**ADDISON AIRPORT
BUILDING REPORT**

Facility Information: **Facility Name:** Terminal Building
Facility Contact: Lisa Pyles **Contact Phone:** 972-450-2878

Accessology Inspector Information:
Inspector: Karen Jackson **Date:** April 17, 2017
Email: Kjackson@accessology.com

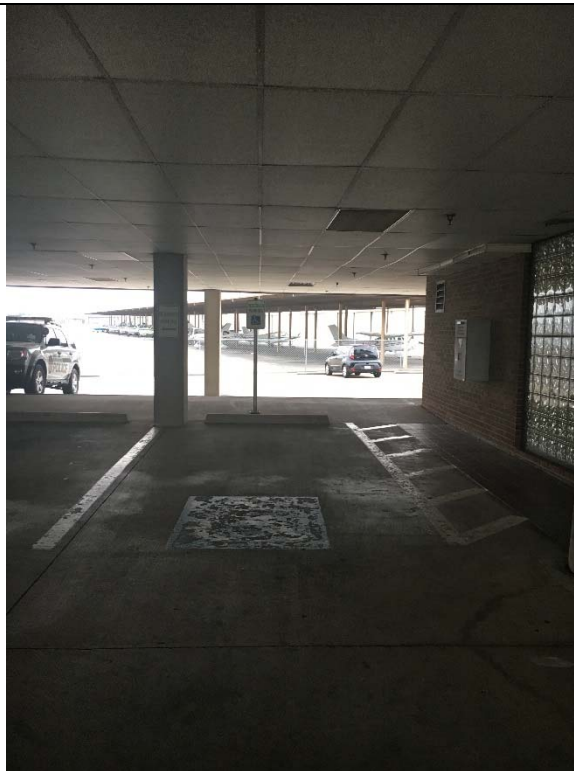
Violation 1 - The accessible parking space on the left facing the street has a running slope of 3.1%.

Violation 2 - The both access aisles facing the street are only 47" wide where a minimum 60" wide access aisle is required. Neither accessible parking space is wide enough to accommodate a van accessible space.

Regrade the accessible parking space to achieve a 1:48 (2.08%) maximum slope in all directions and ensure one of the accessible parking spaces is a

Restripe to allow for 60" minimum wide access aisles and one accessible parking space to be 132" wide van accessible parking space.

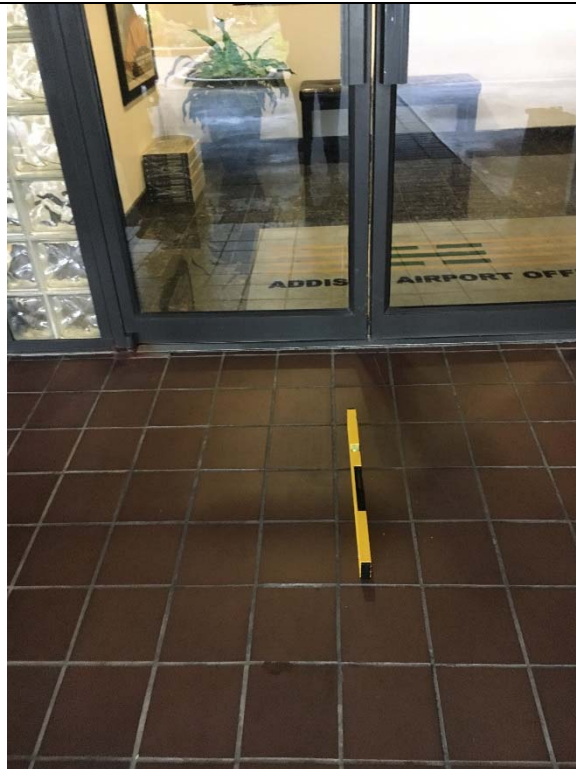
Violation 3 - The left access aisle facing the street has a running slope of 2.3%.

Violation 4 - The accessible parking space provided in the covered parking area has a running slope of 3.1% and a cross slope of 2.3%.

Violation 5 - All accessible parking signs are mounted too low and none of the spaces are marked for "Van Accessible".

Violation 6 – The access aisle serving the covered accessible parking space is partially brick and goes all the way up to the building where a mailbox is mounted on the building and protrudes into the access aisle 12" at 30-1/2" above finished floor.

Regrade the access aisle to achieve a 1:48 (2%) maximum slope in all directions.

Regrade the access aisle to achieve a 1:48 (2%) maximum slope in all directions and ensure the accessible space is a minimum of 132" wide to serve as a van accessible space.

Raise all signage and add van accessible signage to the covered parking as well as one of the uncovered parking spaces.

Relocate mailbox out of the path of circulation path.

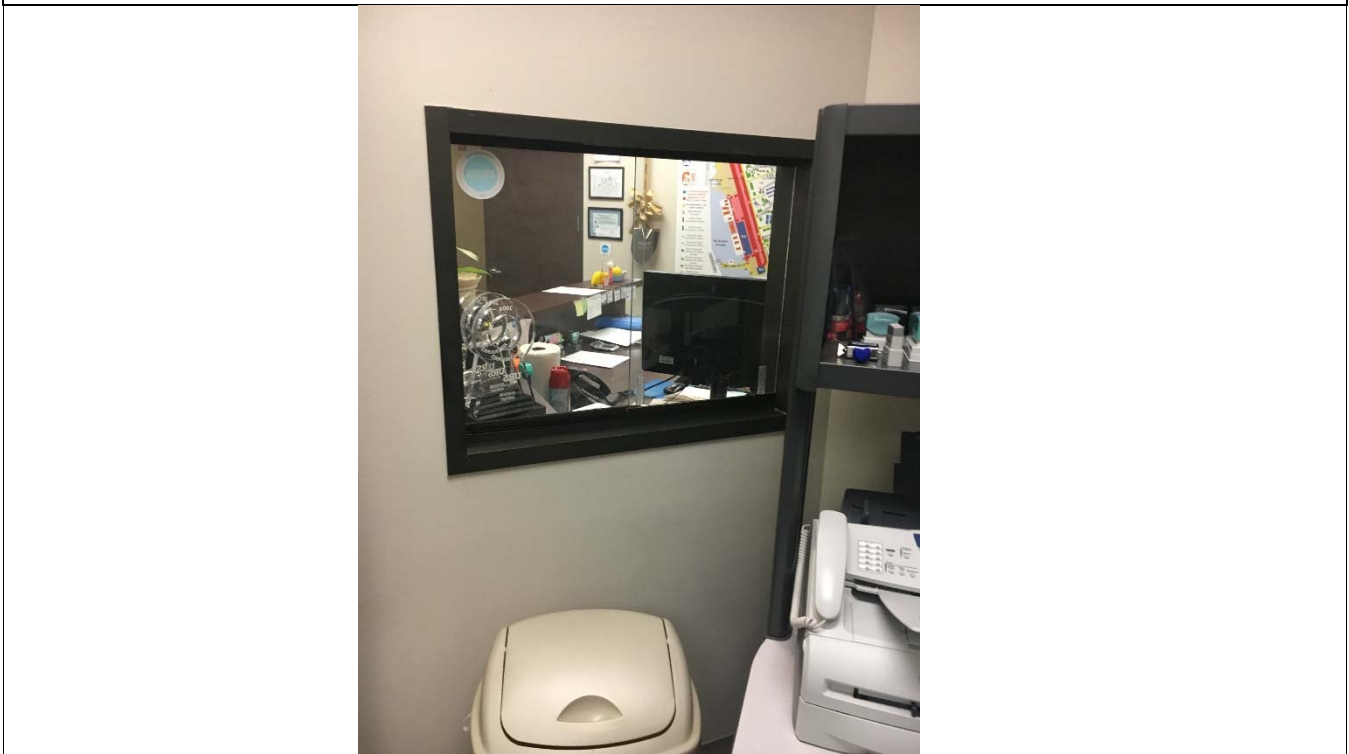
Violation 7 - There are only 3 accessible parking spaces provided, where 5 are required with one being van accessible.

Violation 8 - The landing at the main entrance to the building has a running slope of 7.1%.

Violation 9 - The thermostat control in the hallway is mounted with the highest operable part at 54-5/8" above finished floor where 48" high maximum is required.

Add two accessible parking spaces (one that is van accessible) with access aisles serving them with compliant signage.

Remove and regrade the area in front of the door to achieve a smooth and level landing.

Lower thermostat so the highest operable part is at 48".

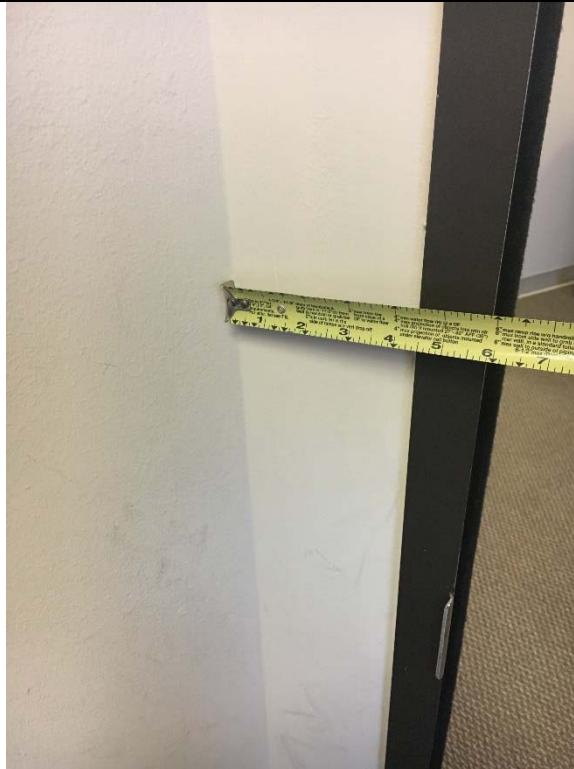
Violation 10 - The fire extinguisher provided in the hallway is mounted with the highest operable part at 54" above finished floor where 48" high maximum is allowed.

Violation 11 - The transaction window provided behind reception is mounted at 40" above finished floor.

Lower the fire extinguisher so the highest operable part is at 48".

Lower counter so it is no higher than 36" above finished floor.

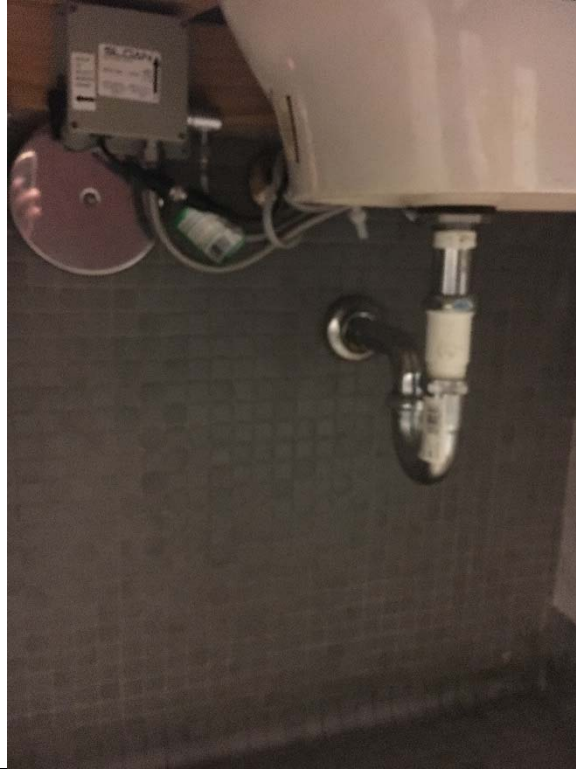
Violation 12 - Two of the offices do not have a minimum of 18" maneuvering clearance on the pull side.

Violation 13 – Women's Restroom - The distance between the door and the lavatory is only 29". A minimum of 48" maneuvering clearance is required.

Violation 14 - Women's Restroom - Pipes under the lavatory are not wrapped.

Violation 15 - Women's Restroom - No accessible stall is provided; only an ambulatory stall is provided.

Violation 16 - Women's Restroom - The feminine product dispenser is mounted with the highest operable part at 55-1/2" above finished floor and requires grasping to operate.

Modify doors to provide an 18" minimum maneuvering clearance.

Reverse the swing of the door.

Provide protection at the exposed drains and water lines under the lavatories.

Modify partitions to provide a wheelchair accessible compartment. Clearance around a water closet shall be 60" minimum measured perpendicular from the side wall and 56" minimum measured perpendicular from the rear wall.

Remove dispenser or replace with a compliant dispenser mounted with highest operable part at 48".

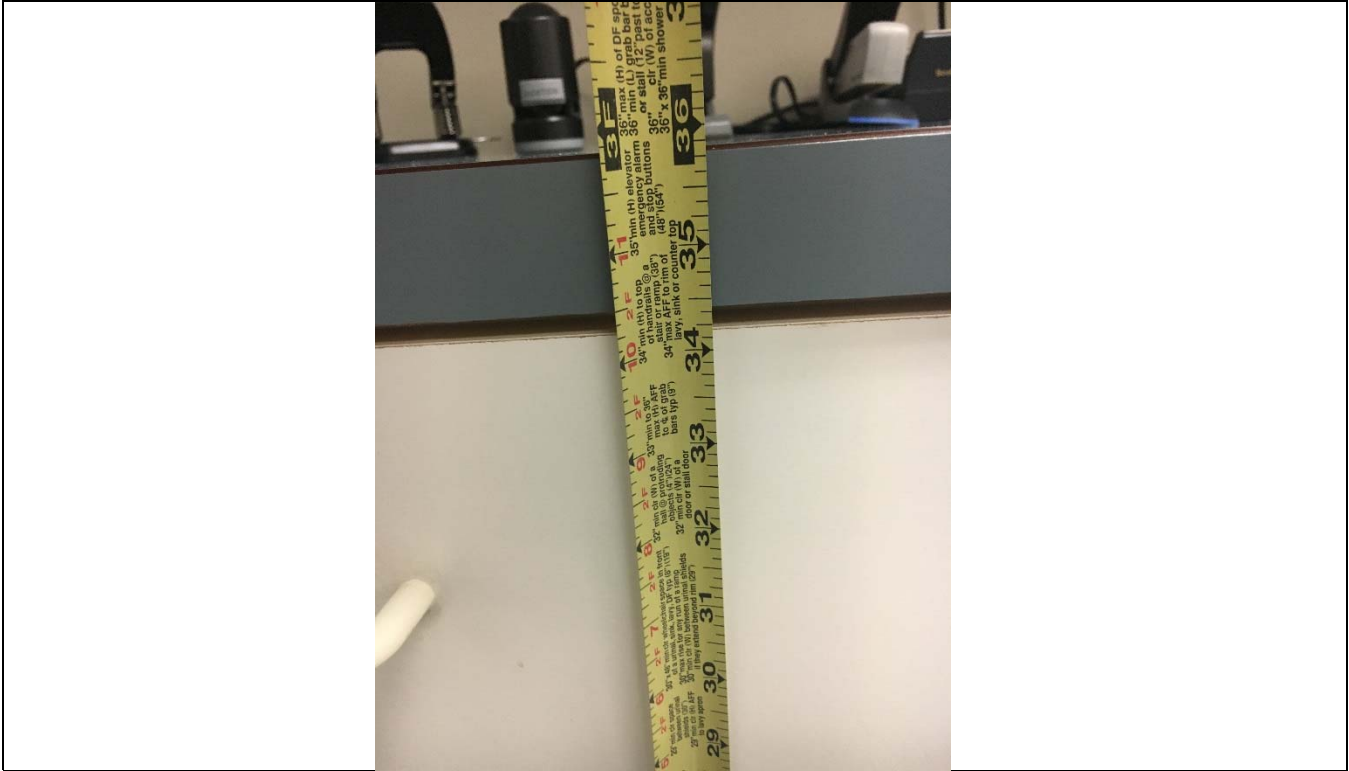
Violation 17 - Men's Restroom - Entry door requires more than 5lbs to open.

Violation 18 - Men's Restroom - Pipes under the lavatory are not wrapped.

Adjust closer.

Provide protection at the exposed drains and water lines under the lavatories.

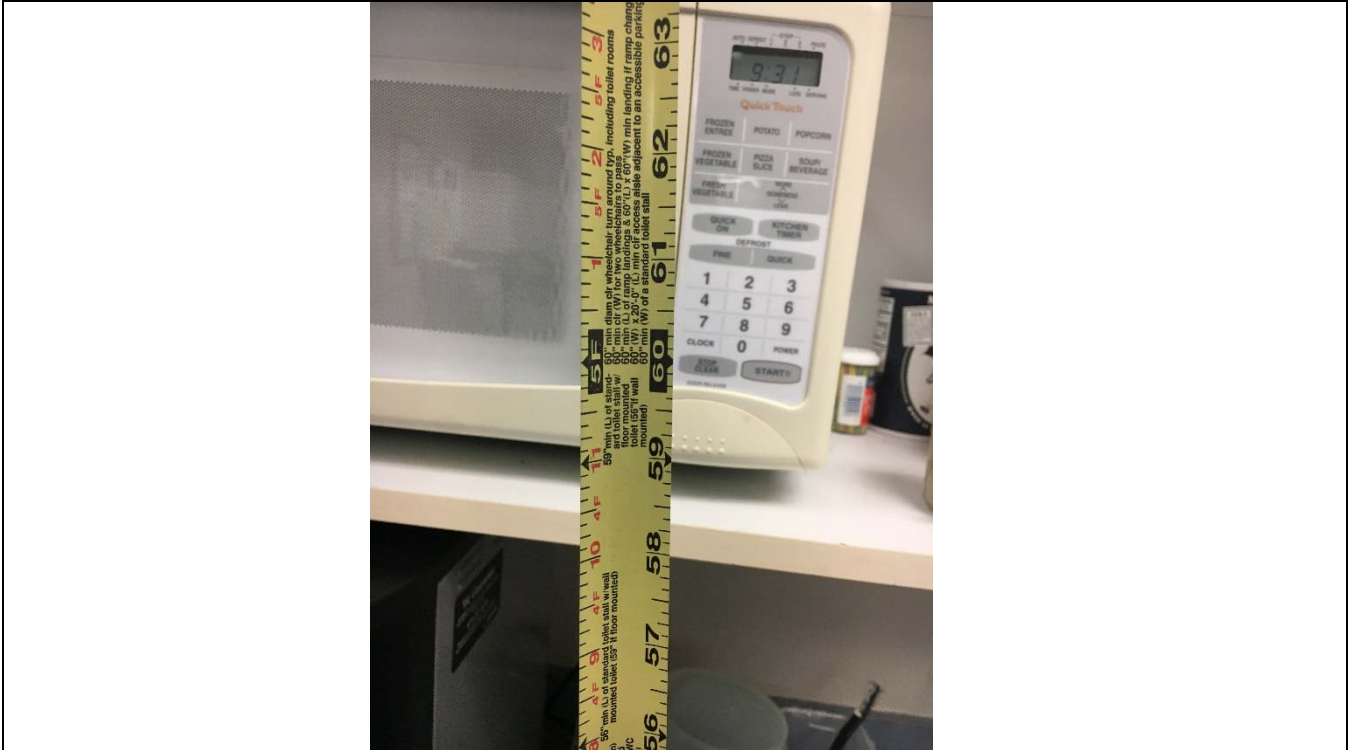
Violation 19 - Men's Restroom - No accessible stall provided; only an ambulatory stall is provided.

Violation 20 - The counter in the break room is 35-3/4" above finished floor to the top of the counter at the sink where a maximum of 34" is required.

Modify partitions to provide a wheelchair accessible compartment. Clearance around a water closet shall be 60" minimum measured perpendicular from the side wall and 56" minimum measured perpendicular from the rear wall.

Possible Solutions: Modify sink to provide 34" maximum height.

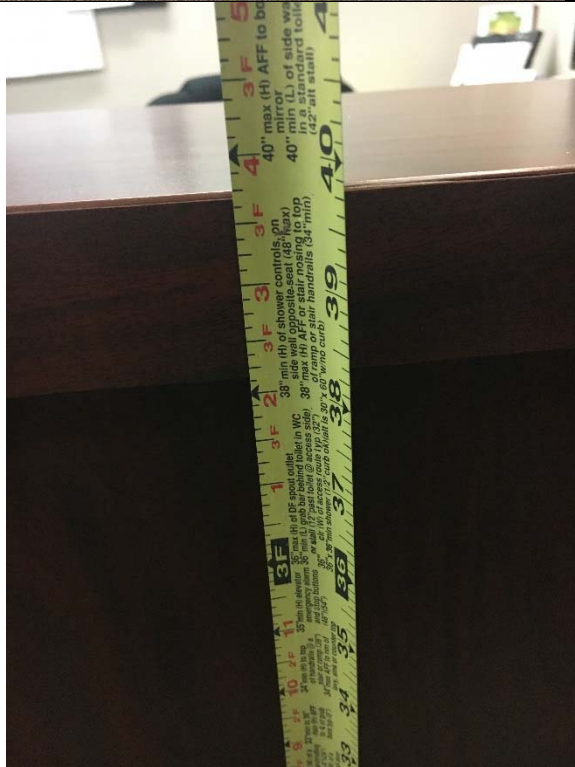
Violation 21 - The counters in the break room are from 35" to 36" above finished floor.

Violation 22 - The microwave is mounted with the highest operable part at 62-1/2" above finished floor.

Violation 23 - The counter in front of the refrigerator reduces the required clear floor space and maneuvering clearance required for use of the refrigerator down to 38".

Possible Solutions: Lower a portion of the counter to 34" above finished floor.

Possible Solutions: Relocate microwave or add another one where it is within reach range.

Remove or modify counter to allow for the requierd clear floor space at the refrigerator.
